APPLICATION FOR AMENDMENT TO
OPERATING LICENSE

Indian Point Unit No. 3

Docket No. 50-286

November 8, 1976

Figure 6.2-1 Facility Management and Technical Support Organization

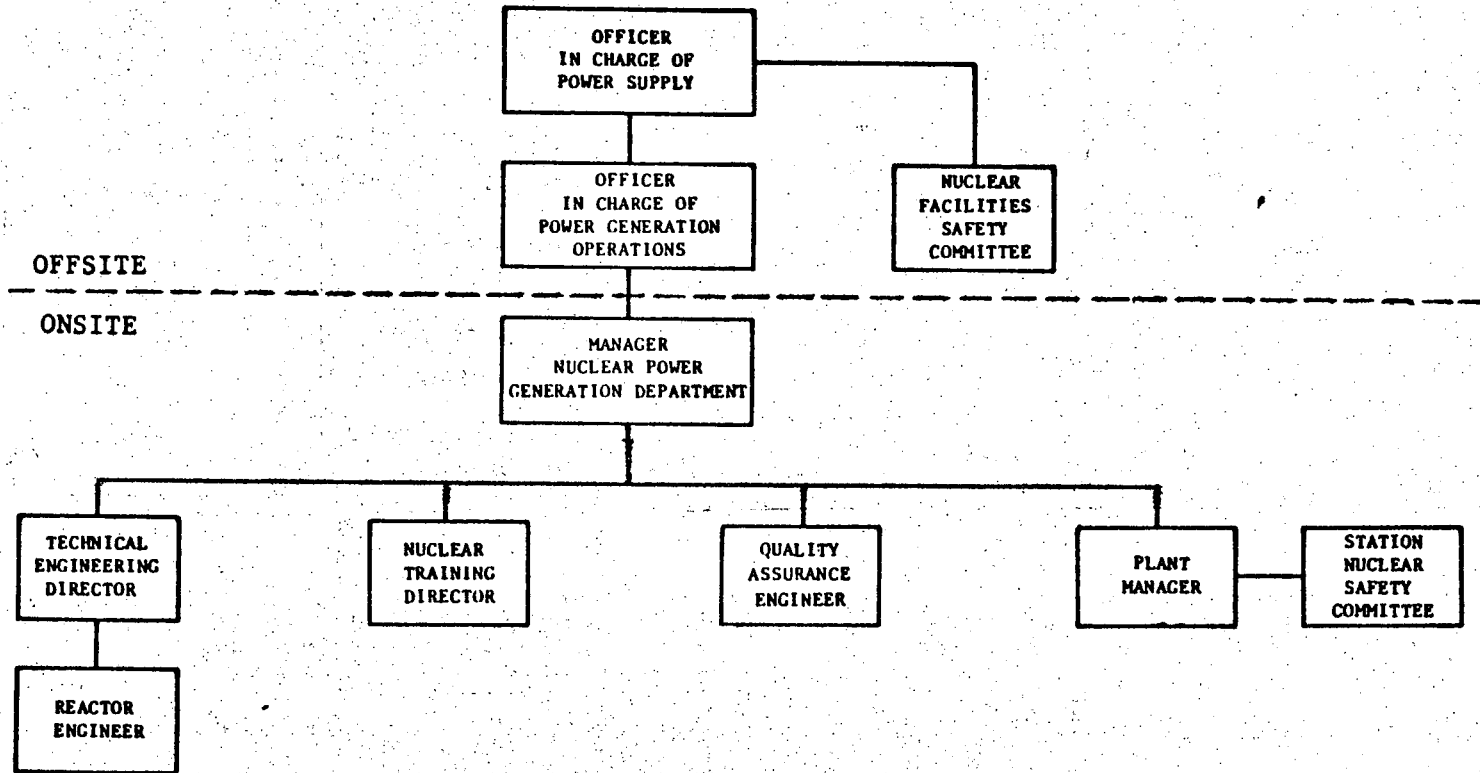
6.2.1 The organization for Facility Management and Technical Support shall be as shown on Figure 6.2-1.

6.2.3 Any change in the organizations shown on Figures 6.2-1 and 6.2-2 shall be reported in accordance with section 6.9.2.f and the implementation of any such change, which is not inconsistent with other requirements of these technical specifications, shall not be deemed a violation.

Figure 6.2-2 Facility Organization

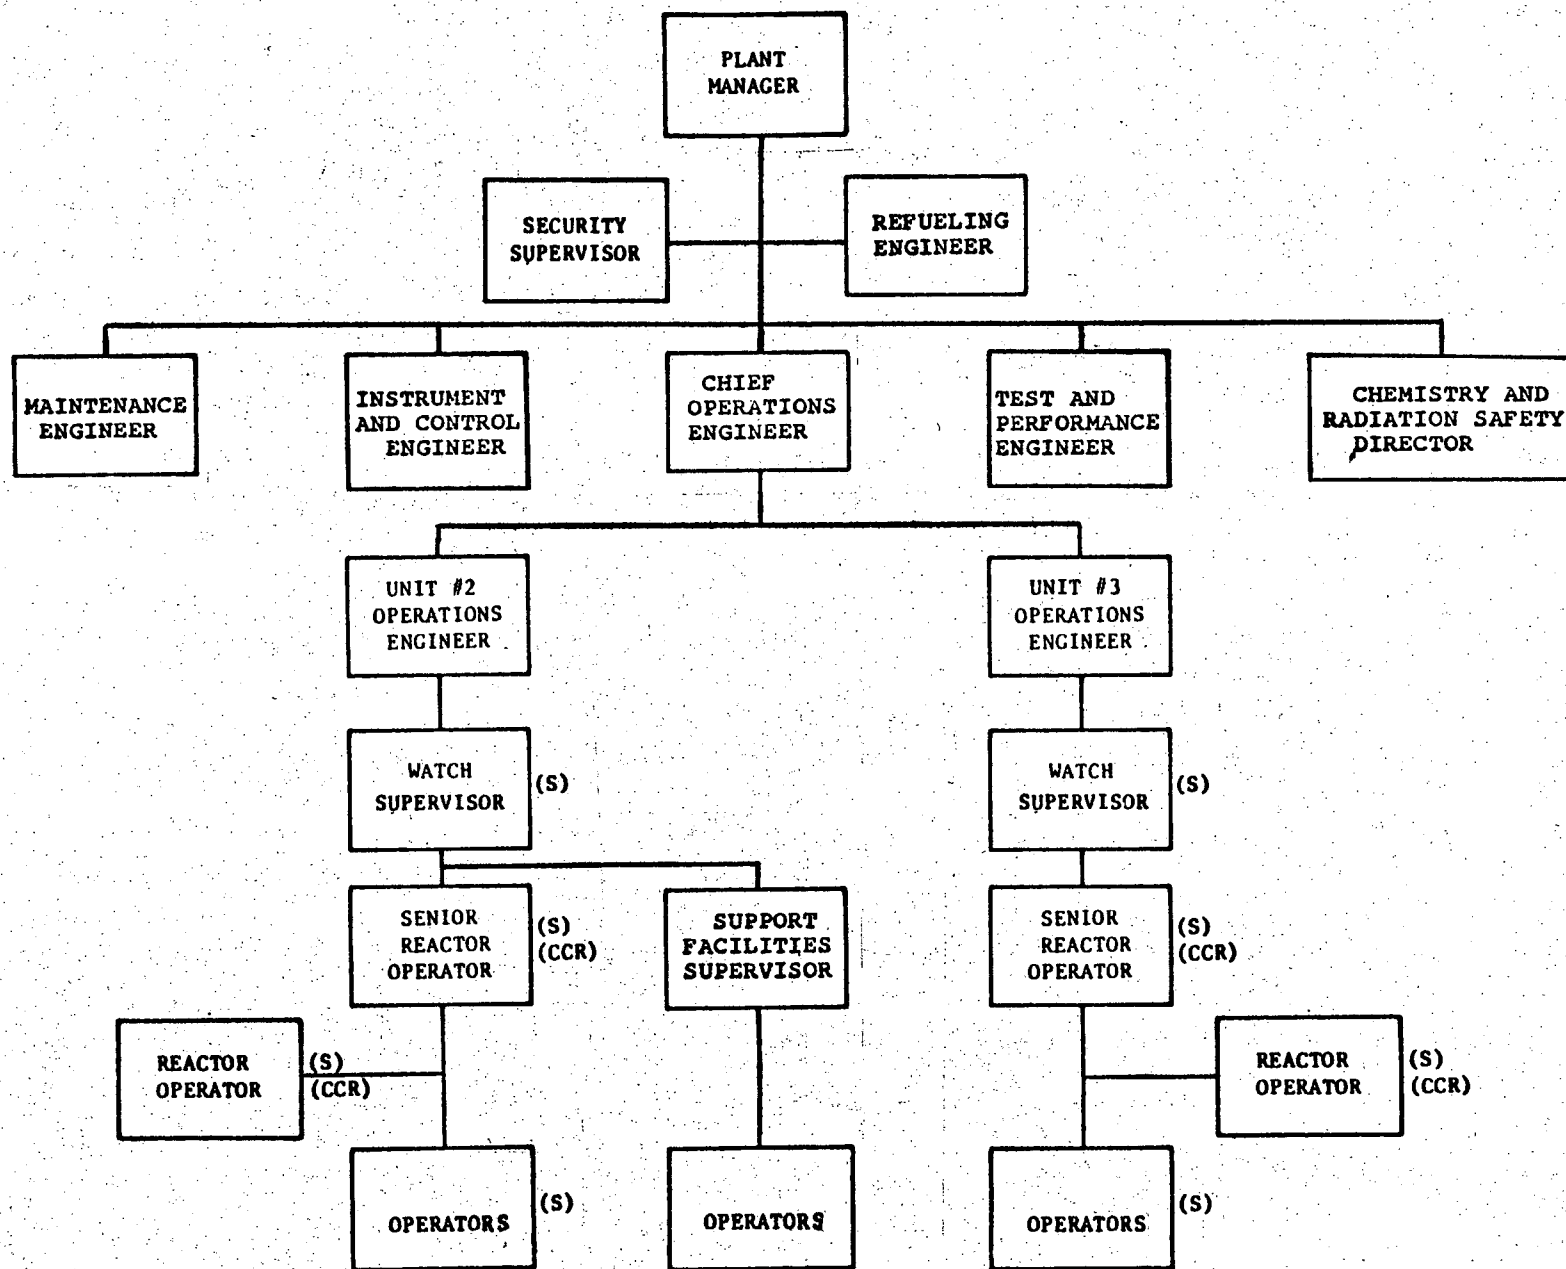
6.2.2 The Facility organization shall be as shown on Figure 6.2-2 and:
